SUBJECT: REQUEST FOR ADDITIONAL INFORMATION REGARDING CENPD-137,  
SUPPLEMENT 2-P

## REQUEST FOR ADDITIONAL INFORMATION CENPD-137, Supplement 2-P

**Subject:** Supplementary Information to FTI's Response to NRC's Request for Additional Information on BAW-10168, Volume II, Revision 2, October 1992; RSG LOCA - BWNT Loss-of-Coolant Accident Evaluation Model for Recirculating Steam Generator Plants.

Figure 11: Revised FTI SBLOCA 4-Loop RSG Pump Suction Noding Details

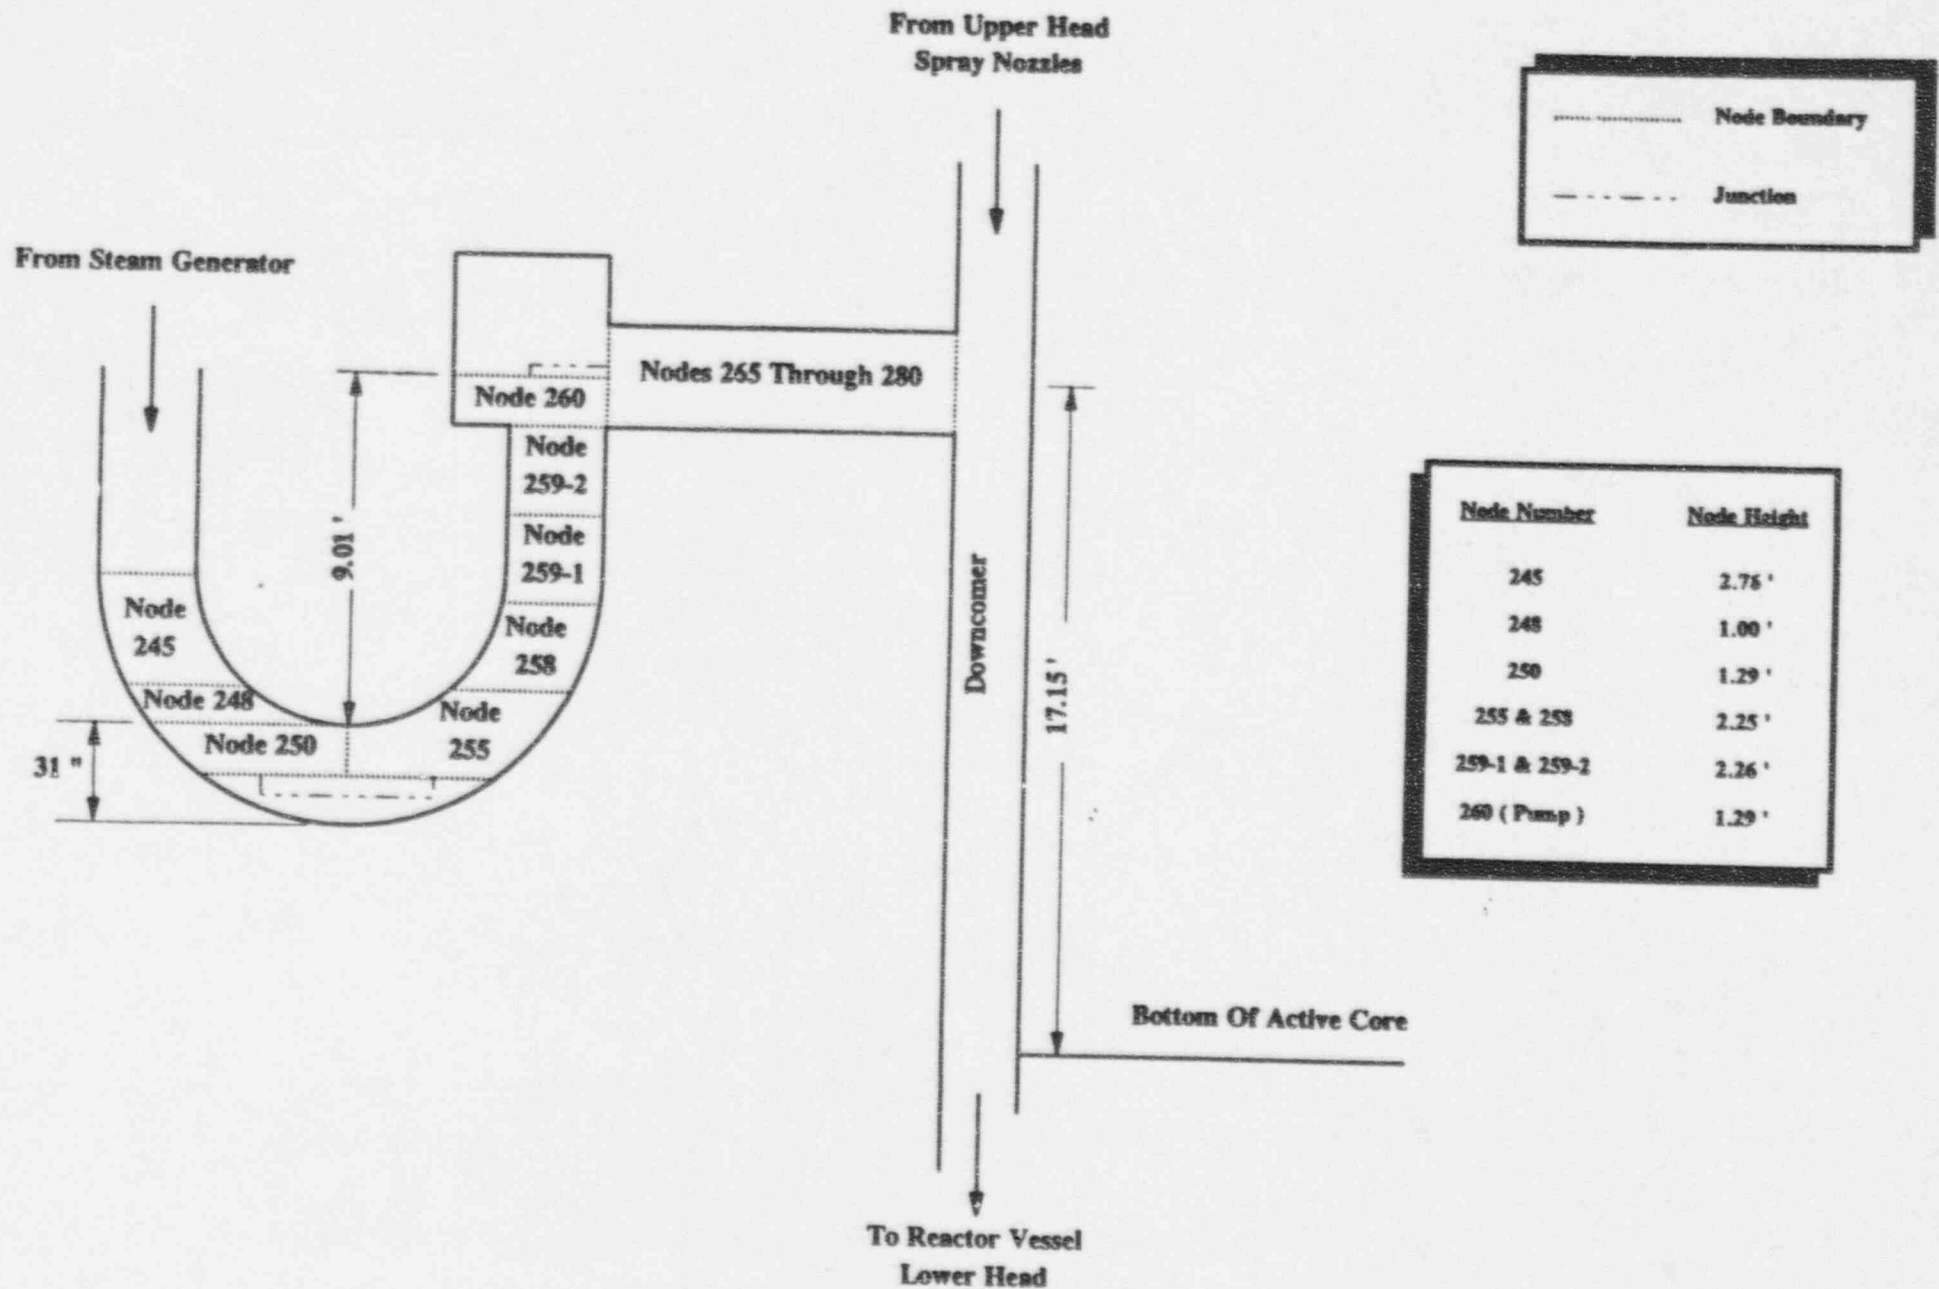
The early voiding of the pump node for the 2.0-inch break case, as discussed in the previous section, may have been caused by the height of Node 260. To study the sensitivity of pump node size, the base input model was modified by dividing the pump volume into three nodes (259-1, 259-2, and 260) as shown in Figure 11. Node 260 still represents the pump. In this case the 2.0-inch break case did not clear the loop seal. For a 2.1-inch break case, the loop seal cleared after about 3300 seconds. Collapsed liquid levels in the loop seal and core and the void fractions in the loop seal nodes, pump node, and the pump discharge node of the broken loop are shown in Figures 12 through 22. From these figures the following observations can be made. Steam venting through the loop seal starts after Node 245 is highly voided. This occurs at about 1400 seconds. The void fraction in Node 259-1, which is part of the actual pump, is close to the void fraction in Node 258. Node 260 is highly voided and the void fraction in node 259-2 is somewhere between the values for Nodes 259-1 and 260. The void distribution in the upside U-bend, including the pump volume, is improved over that in the base calculation. The venting of steam causes the liquid level in the upside of the U-bend to decrease, reducing the core level depression. Figures 12, 14, and 15 show liquid level oscillations on the order of 1.0 foot in the down side of the U-bend from about 1500 seconds until the time of loop seal clearing, about 3300 seconds. The oscillations are mainly caused by the condensation of steam on the cold ECC water

The revised pump noding will be used in SBLOCA EM. However, this model change does not impact previous EM studies and benchmarks.
